REMARKS

Amendments to the Drawings:

FIG. 1

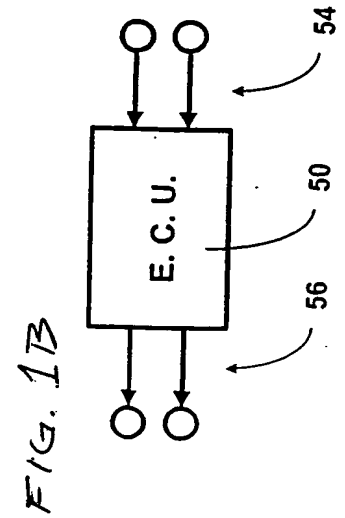
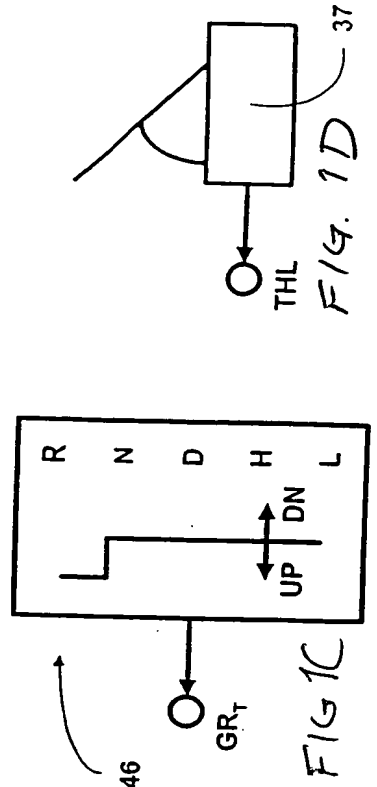
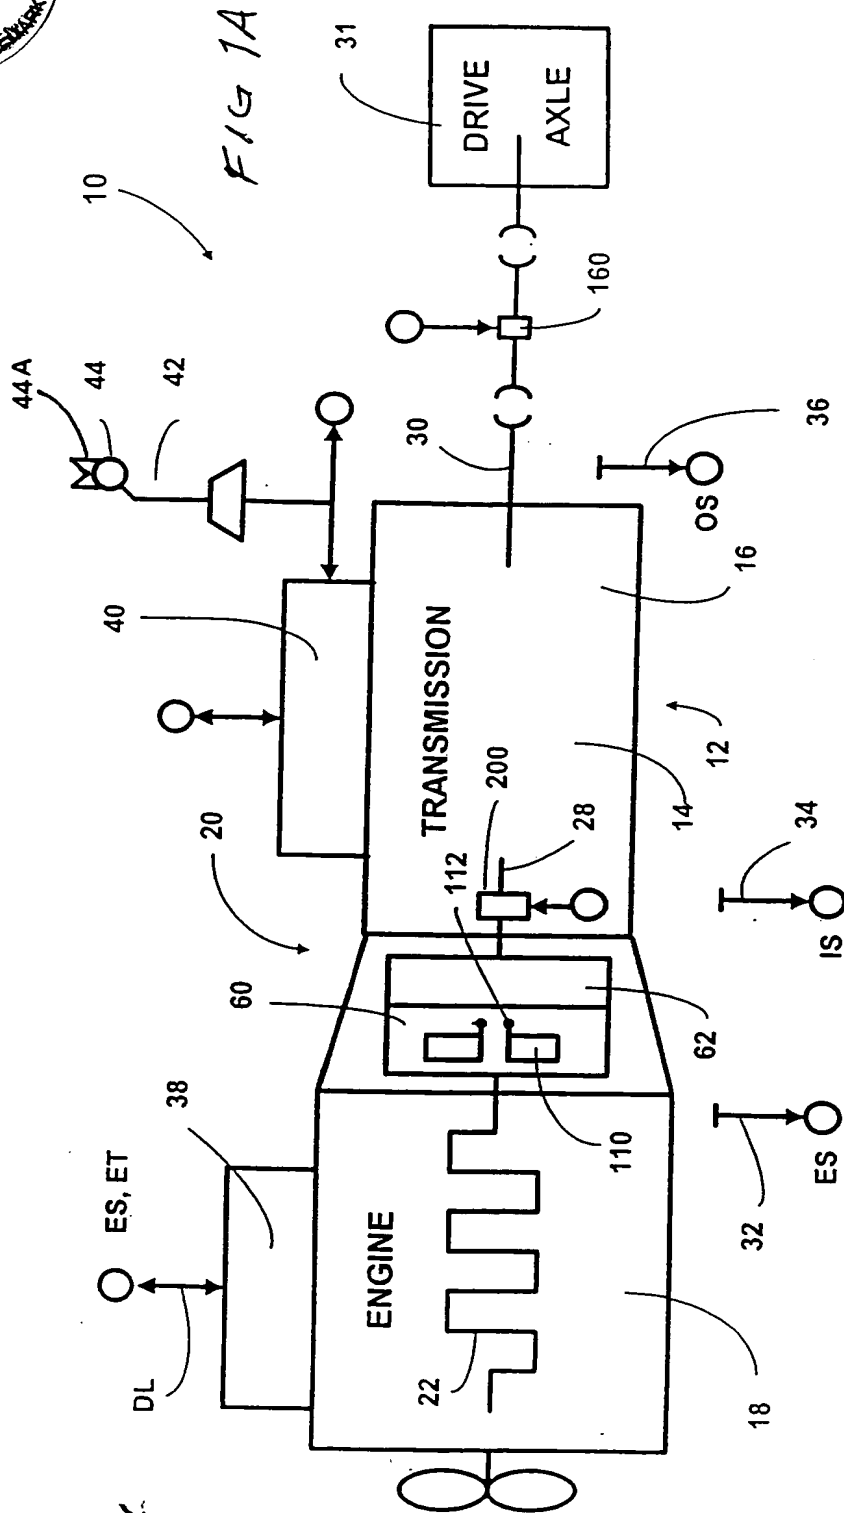
The drawings sand objected to as failing to comply with 37 CFR 1.84(p)(4). The Examiner has indicated that the Applicant may label the figures 1A-1D. The drawings have been amended consistent with the recommendation of the Examiner.

Figure 1 has been amended, dividing it into Figure 1A, 1B, 1C and 1D to provide individual labeling for each of the elements found on that sheet. The bracket has been eliminated. The label "FIG 1" has been deleted. Labels "FIG 1A", "FIG 1B", "FIG 1C", and "FIG 1D" have been placed proximate to each of the four main elements of the drawing. The changes are shown in red in the accompanying marked-up Annotated Sheet that comprises the following page of this paper. The replacement sheet is provided in clean copy form herewith.
